**COMMONWEALTH OF KENTUCKY
BEFORE THE PUBLIC SERVICE COMMISSION**

ELECTRONIC 2021 INTEGRATED)	CASE NO.
RESOURCE PLAN OF DUKE)	2021-00245
ENERGY KENTUCKY, INC.)

**SIERRA CLUB’S PREHEARING COMMENTS ON
DUKE ENERGY KENTUCKY’S 2021 INTEGRATED RESOURCE PLAN**

**Analysis of Public Information Suggests That a Clean Energy Portfolio
Can Cost Effectively Replace East Bend 2 Coal Unit by 2022-2024**

Figure 1: Cost comparison of building and operating a new clean energy portfolio vs. cost of operation of coal-fired East Bend 2

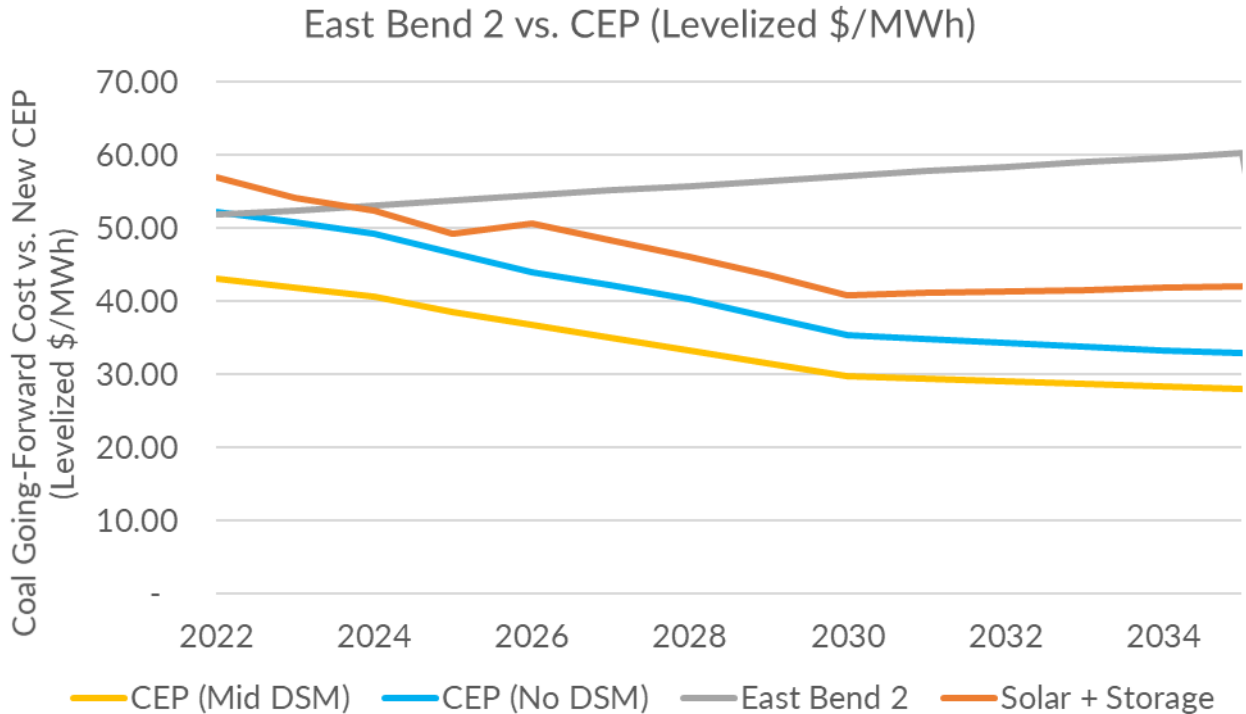
The results of the CEP model are shown below in Figure 1 (cost comparison with coal plant) and Table 1 (technology mix of the clean energy portfolio). **The levelized cost of energy (LCOE) of the CEP would be lower than the cost of continuing coal operations by the year 2022, under the DSM scenario; by 2023, under the no-DSM scenario; and by 2024, under more limited solar-plus-storage scenario. Assuming replacement of East Bend 2 in 2027, these replacement options would save customers \$239 million, \$134 million, or \$61 million, respectively, through the currently projected the lifetime of East Bend 2.** These savings are calculated as the net present value of the coal plant costs that would be avoided by retirement, less the annualized clean energy portfolio costs, between 2027 and 2035. More details on our methodology and data sources are discussed in the Sources and Methodology section below.
